ORDINANCE NO. 5089

AN ORDINANCE APPROVING A LANDSCAPE PLAN AND STREET TREE PLAN FOR THE BAKER CREEK NORTH SUBDIVISION

DECISION, CONDITIONS, FINDINGS OF FACT AND CONCLUSIONARY FINDINGS FOR THE APPROVAL OF A LANDSCAPE PLAN AND STREET TREE PLAN FOR THE BAKER CREEK NORTH SUBDIVISION

DOCKET: L 12-19 (Tree Removal, Landscape Plan and Street Tree Plan)

Pump Station 'Tract G':

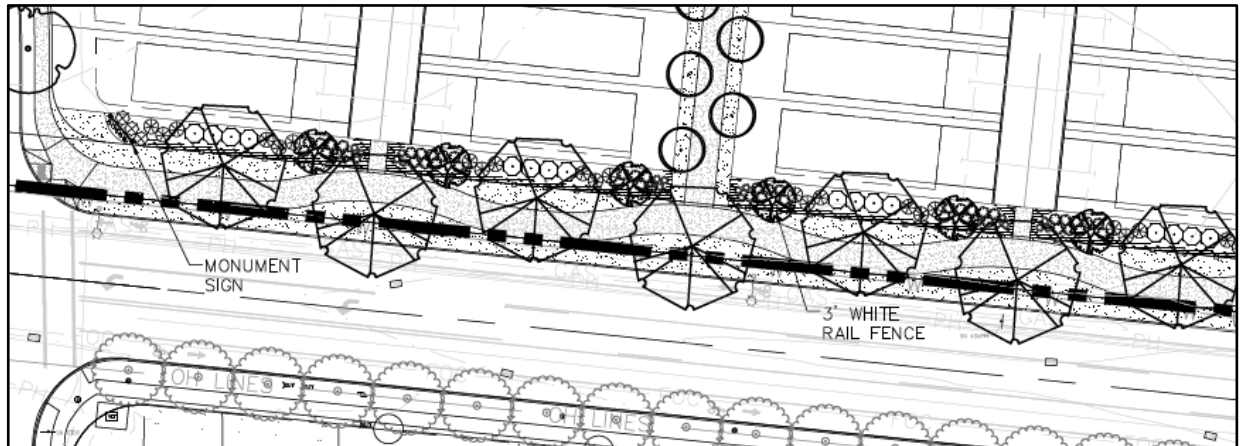
Landscaping has been proposed in excess of the 25 percent minimum for each common tract in the planned development, except for Tract G, the sewage pump station tract. Therefore, a condition is included requiring a minimum 25 percent of the gross area of Tract G be provided with landscaping.

Landscaping was not proposed for Tract G at the intersection of Charles Street and Alfred Drive, where a sewer pump station is located. Tract G is adjacent to residential lots 60, 109, and 110, and is across the street from lots 49, 111, and Open Space Tract F. There is no screening or buffering of the pump station from the adjacent residential uses. A condition of approval requiring landscaping to screen and buffer the sewage pump station has been included.

CONDITION FOR FINDING: That landscaping be provided for Sewage Pump Station Tract ‘G’. Landscaping shall be provided at an amount equal to or greater than 25 percent of the gross area of the tract, and shall provide screening of the pump station from surrounding properties.

Open Space 'Tract I':

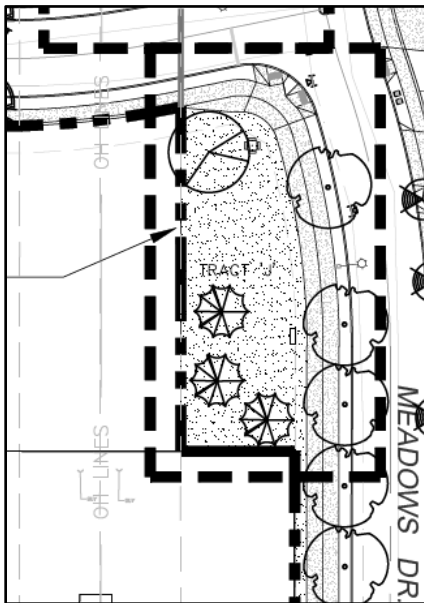
Based on comments from McMinnville Water & Light, trees surrounding the electric substation should be limited in height to 25 feet. A condition is included limiting the height of any trees located in Open Space Tract I to a maximum mature canopy height of 25 feet.

Open Space 'Tract J':

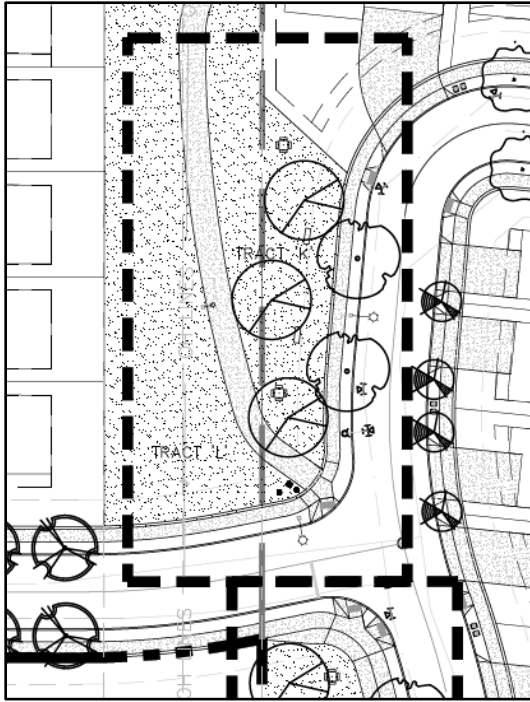
Douglas Fir trees can grow to approximately 100 feet tall and 30 feet wide, and Sunburst Honey Locust grow to approximately 40 feet tall and wide. Based on comments from McMinnville Water & Light, trees surrounding the electric substation should be limited in height to 25 feet. Additionally, trees adjacent to the transmission easement should be limited in height 40 feet and located such that no canopy encroaches into the transmission easement. A condition is included limiting the height of any trees in Open Space Tract J adjacent to the electric substation to a maximum mature canopy height of 25 feet, and no tree in Tract J shall

exceed a maximum mature canopy height of 40 feet or be located such that no canopy encroaches into the transmission easement.

Open Space 'Tract K':

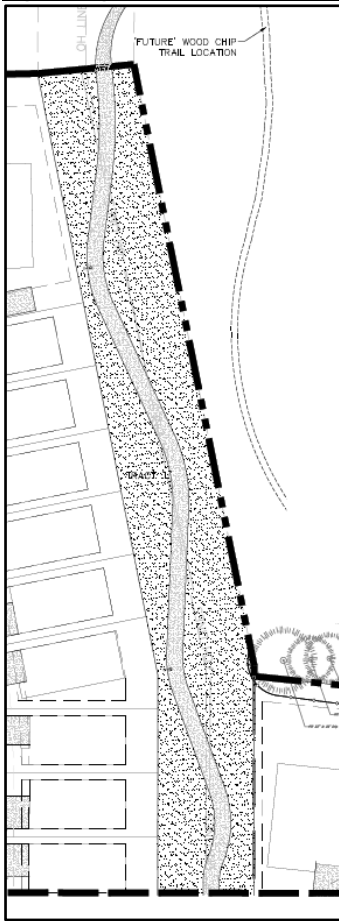
Sunburst Honey Locusts grow approximately 40 feet tall and wide. Based on comments from McMinnville Water & Light, trees in Tract K should be located such that no canopy encroaches into the transmission easement. A condition is included limiting the height of any trees in Open Space Tract K to a maximum mature canopy height of 40 feet and to locations such that no canopy encroaches into the transmission easement.

Open Space & Access Easement 'Tract L':

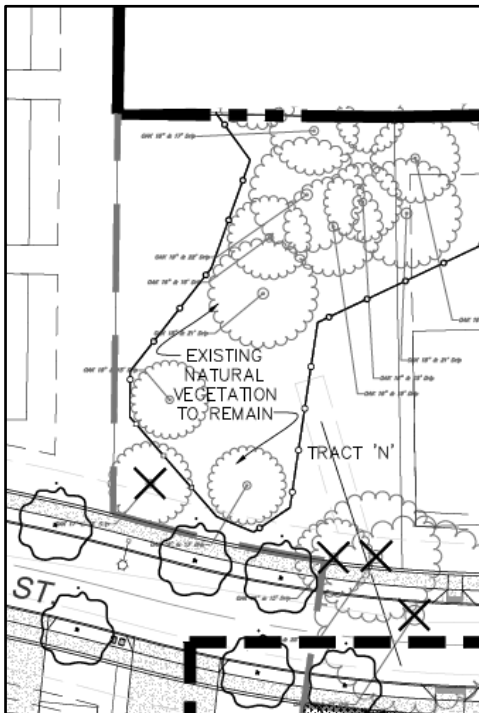
Additionally, no street trees should be located within the public right-of-way in the transmission line easement, where they would be in incompatible with electrical transmission lines overhead.

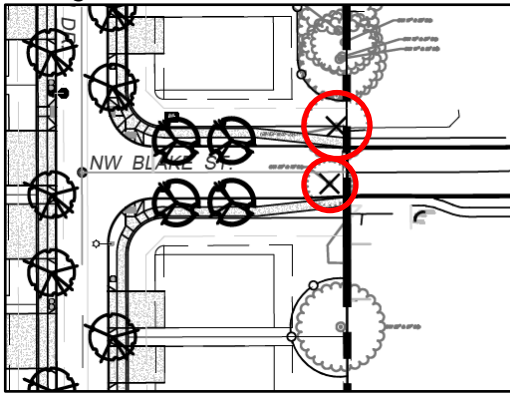
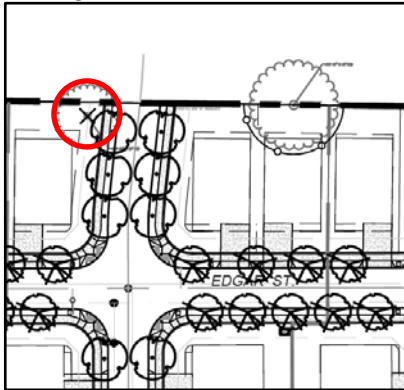
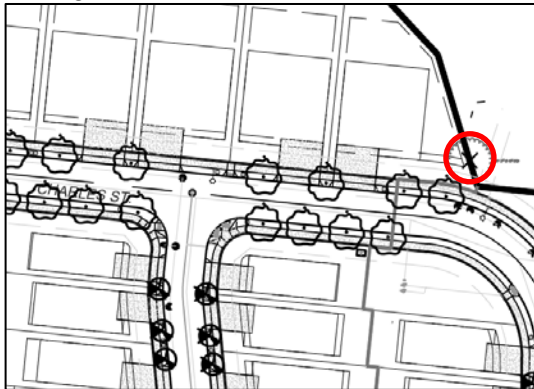
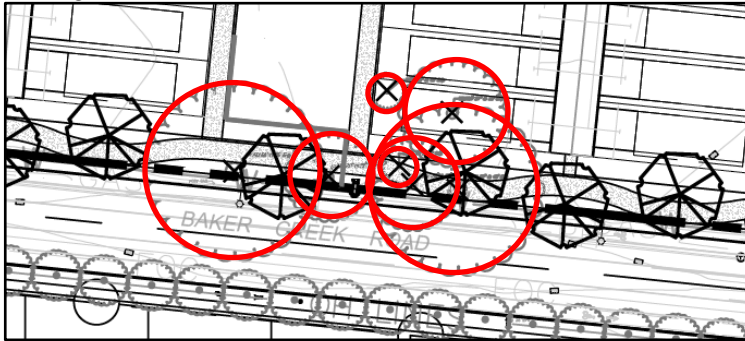
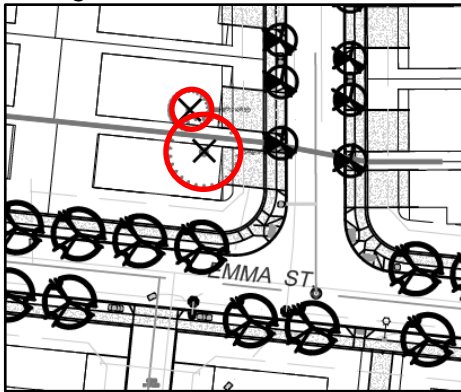
FINDING: SATISFIED. The City concurs with the applicant's finding's finding. Drawing L1.0 Street Tree Plan indicates that 17 trees are proposed for removal. The applicant has indicated the location, type, and size of the trees requested for removal on the Street Tree Plan, shown in more detail in Street Tree Plan Enlargements A-F and accompanying tree schedules below. The requested tree removals are not designated as exempt by the zoning ordinance, therefore the requested removals require City approval.

CONDITION FOR FINDING: That only the 17 trees identified for removal on Drawing L1.0 Street Tree Plan shall be approved for removal.
